ALTERNATOR AND A/C BELT IDLER REPLACEMENT

Prevost vehicles

Special Bulletin

SP17-303D

Figure 1: 450334 Idler assembly Exploded View.

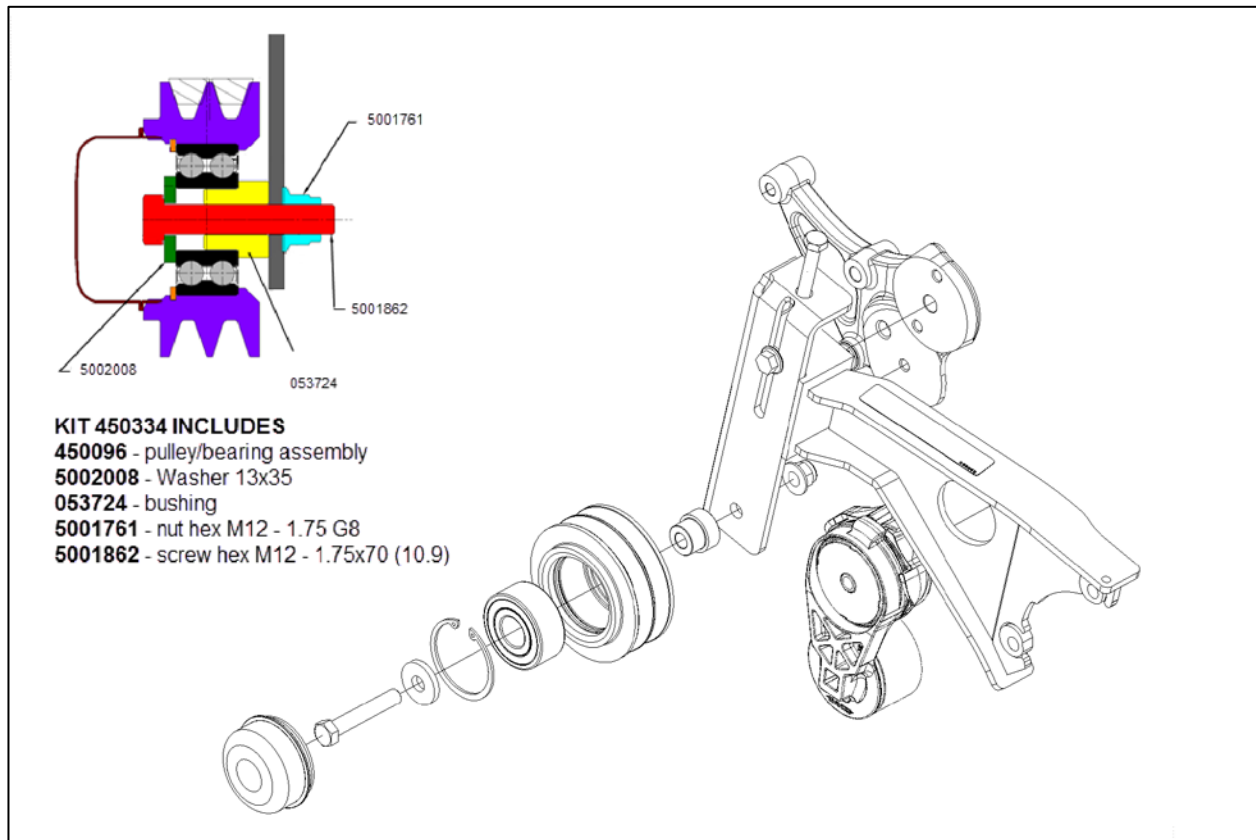
On the vehicles affected by this bulletin, replace two idlers by an improved version on the alternator drive belt and on the A/C belts.

5. Install the new idler. (Figure 1, Figure 3)

Tighten screw to 59 lb-ft

Figure 2: 010074 Idler Assembly Exploded View

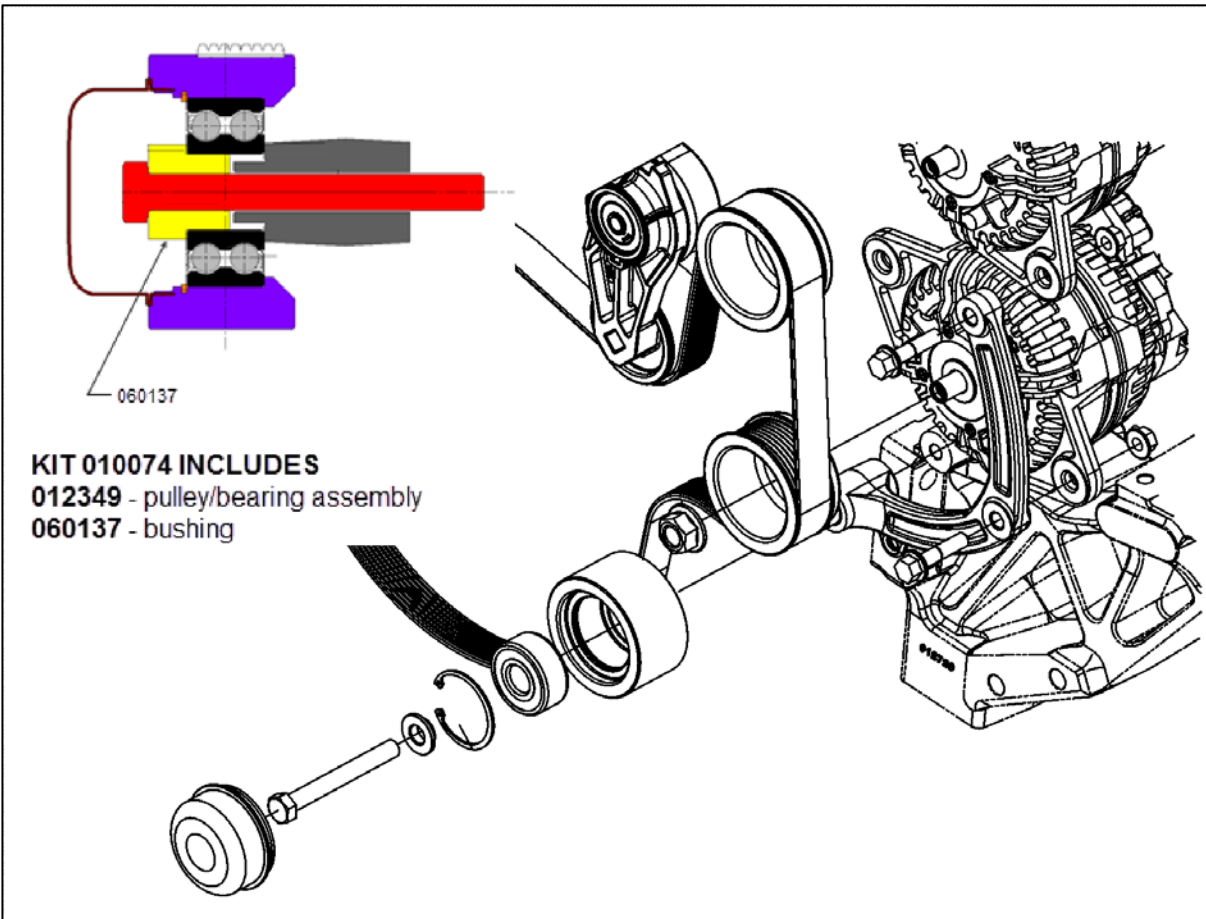
8. Install the new idler assembly #450334 on the supplied idler & alternator bracket #21134692. (Figure 2, Figure 4)

Tighten screw to 82 lb-ft

Figure 3

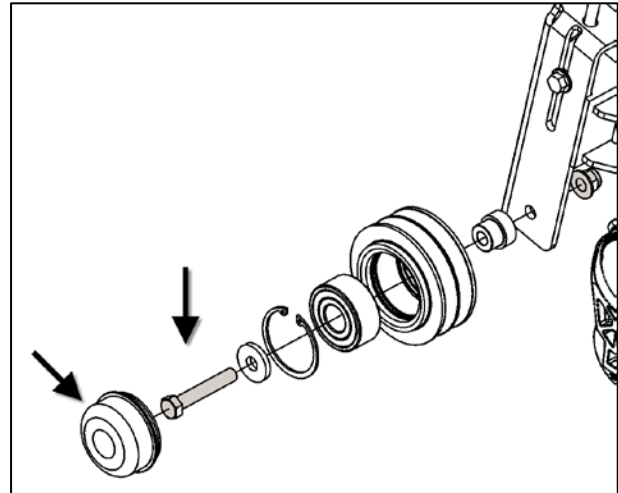
6. Install dustcap.(Figure 3)

Figure 4

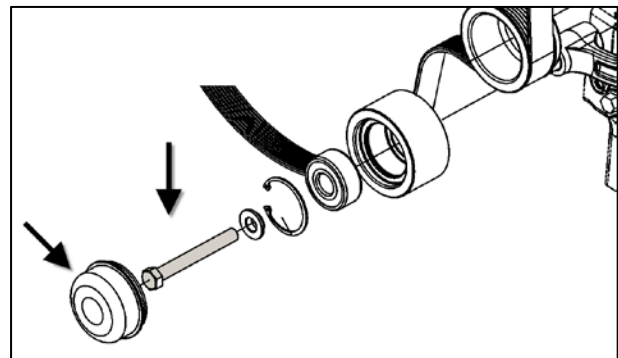
9. Install dustcap. (Figure 4)

Figure 5

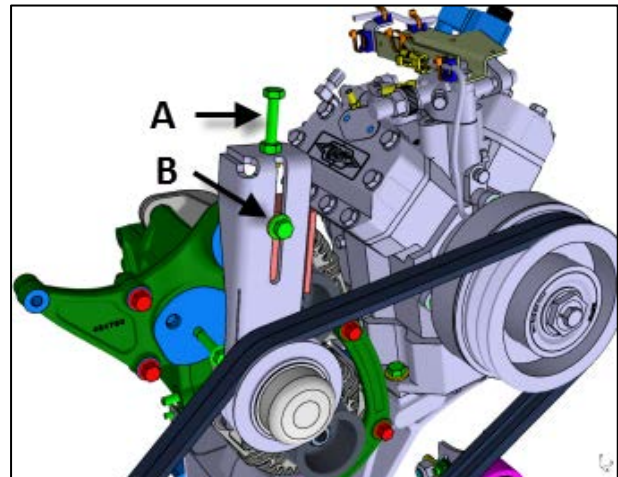
12. For the A/C belt, adjust tension by turning Adjustment Screw **A** (Figure 5). Use the jam nut at the base of Screw **A** to keep proper tension adjustment.

13. Using a Dayco "Kriket" gage #7770002, adjust tension within the following values for *BX71 Double Belt*

90 - 100 lbs. – new

75 - 85 lbs. – used

14. When proper tension is achieved, tighten screw **B** to **43 lbf-ft. (58 N-m)**.
